UNITED STATES PATENT AND TRADEMARK OFFICE

APPLICATION NO.	FILING DATE	FIRST NAMED INVENTOR	ATTORNEY DOCKET NO.	CONFIRMATION NO.
09/284,117	08/14/2000	Thomas Medebach	MULL01/00028	1914

Office Action Summary	Application No. 09/284,117	Applicant(s) MEDEBACH ET AL.	
	Examiner Jerry Redman	Art Unit 3634

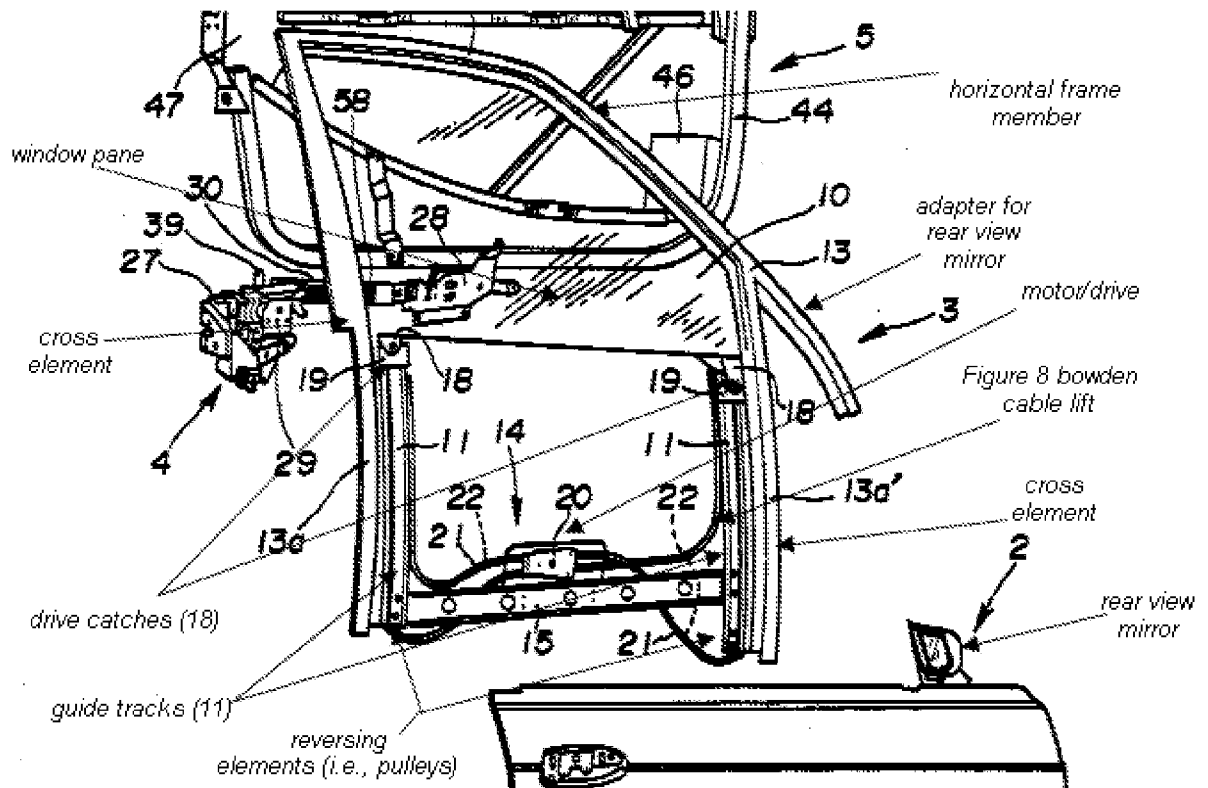
As best understood, claims 1-16 are further rejected under 35 U.S.C. 102(b) as being anticipated by Yamagata et al. (5,226,259). As shown in the Figure below, Yamagata et al. (5,226,259) discloses a frame member comprising a horizontal member, two vertical/cross members (13a and 13a'), a pair of guide tracks mounted to the vertical members (13a and 13a'), "adjustable" drive catches (18, and mounted via fastener to element 19), a Figure 8 Bowden cable connected to a motor drum (20) and

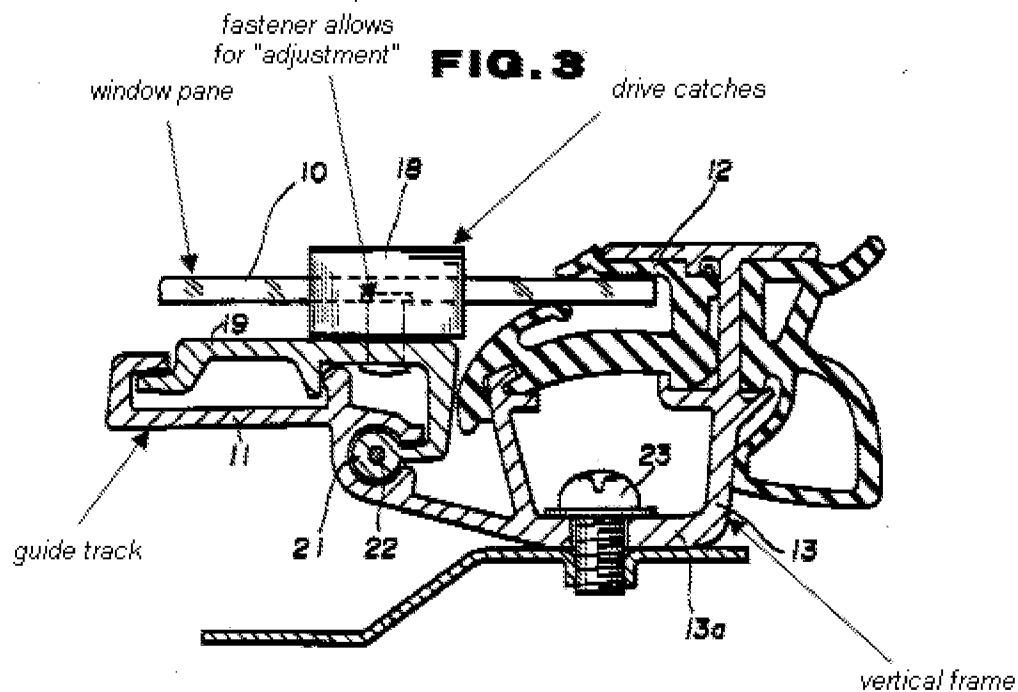
to the drive catches (18), which drives a window pane (10) vertically along the guide tracks (13a and 13a') and the frame member is inserted into a "door hollow" (5).
